**CITY OF KELOWNA
MEMORANDUM**

APPLICATION NO. DP09-0043

AT: 130 Rutland Road

PURPOSE: TO OBTAIN A DEVELOPMENT PERMIT FOR FORM AND CHARACTER OF A SECOND STOREY EXPANSION IN ORDER TO FACILITATE THE PROVISION OF THREE RESIDENTIAL UNITS.

FRONT ELEVATION

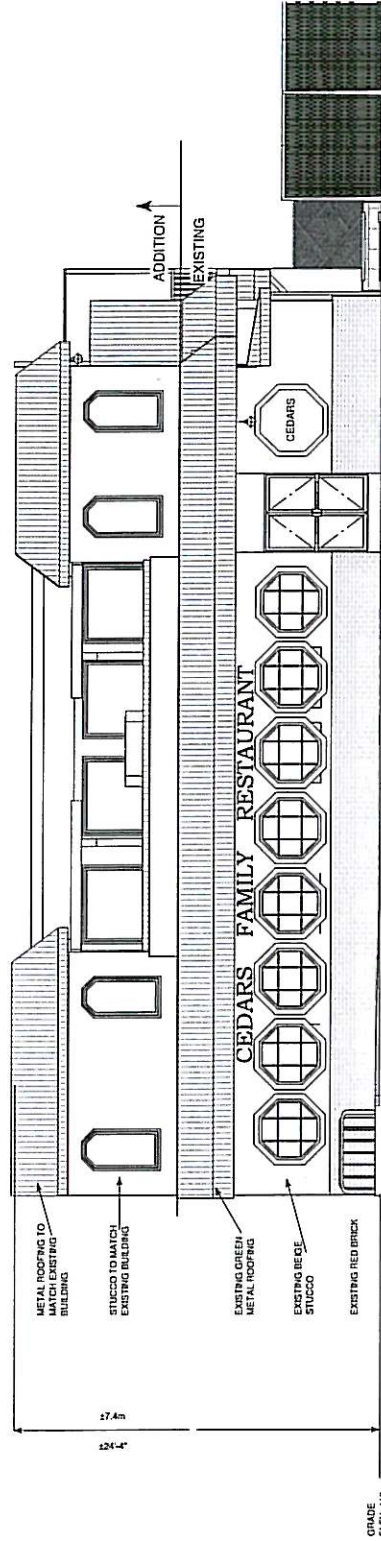
APC commented that to improve the application, considerable landscape improvements should be incorporated and that improvements to the residential entrance should be integrated into the elevations to pronounce the entrance feature. *The applicant has revised their plans to reflect the suggestions made.*

Additionally, an entry roof feature was added to help identify the residential entrance. While there was not adequate space to incorporate walkways at the front and side of the building, the applicant has agreed to create an at-grade stamped concrete area to visually differentiate the pedestrian walkway from the commercial traffic and parking.

SECOND FLOOR PLAN

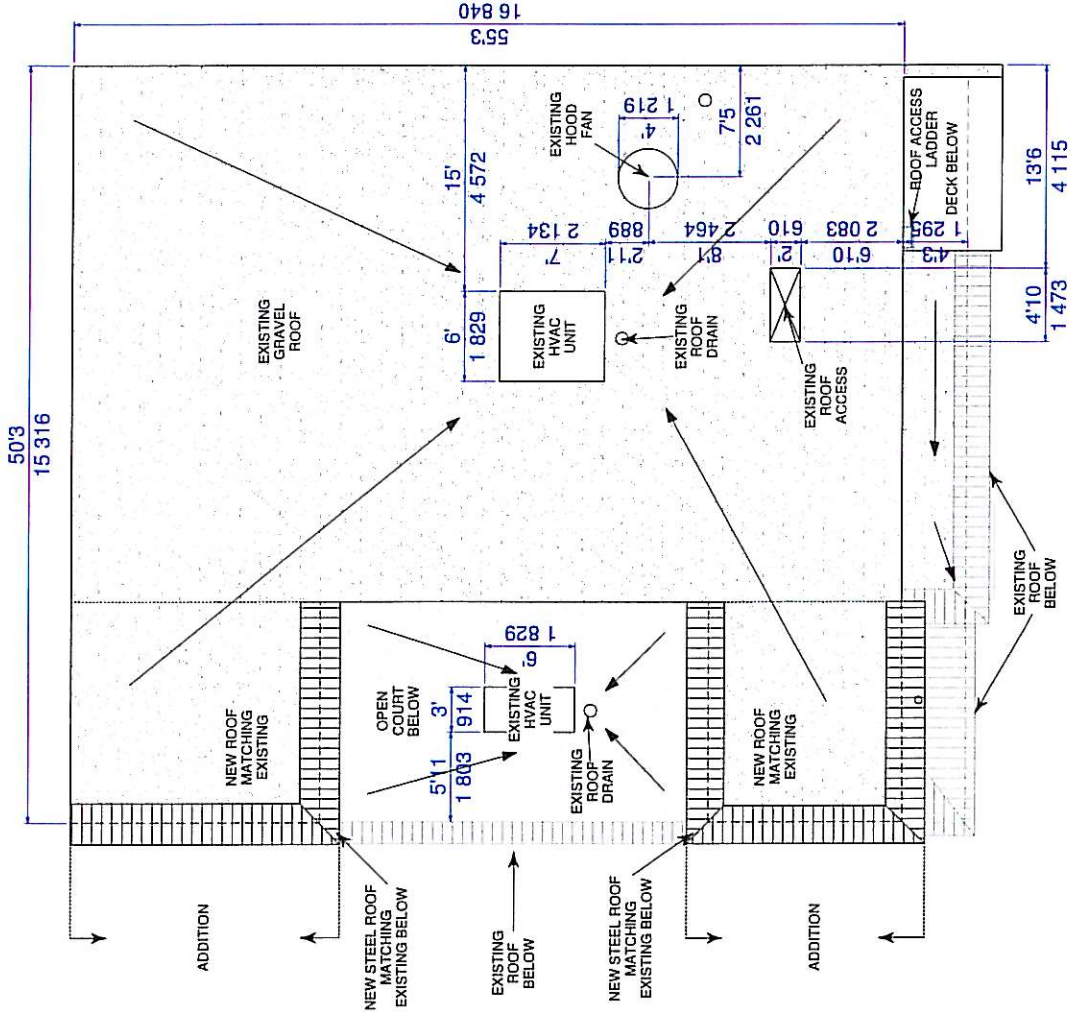
Detailed code analysis required. Existing exit from restaurant on main floor at rear of building and proposed second storey exit (west elevation) do not meet requirement of BCBC 2006. Bedroom, including window in unit 'C' at rear of building (west elevation) not to requirements of building code. *These changes have been made to the provided drawings.*

NOTE:
S/M. BEDROOM WINDOW SIZE 4'-0" x 3'-0"
(1.2m x 0.9m). OPENING 20" x 32" (0.5m x 0.8m) =
640sq.in. (0.4m²)
B.C.B.C. MIN REQUIREMENT 0.35m²
(9.11.2.2.d)

NOTE:
-1 HOUR FIRE-RESISTANCE FROM
RESTAURANT TO DWELLING UNIT
B.C.B.C. (table 3.1.3.1)
-FIRE-RESISTANCE RATING OF
EXIT SEPARATION
MIN 45 minutes
B.C.B.C. (3.4.4.1.1)
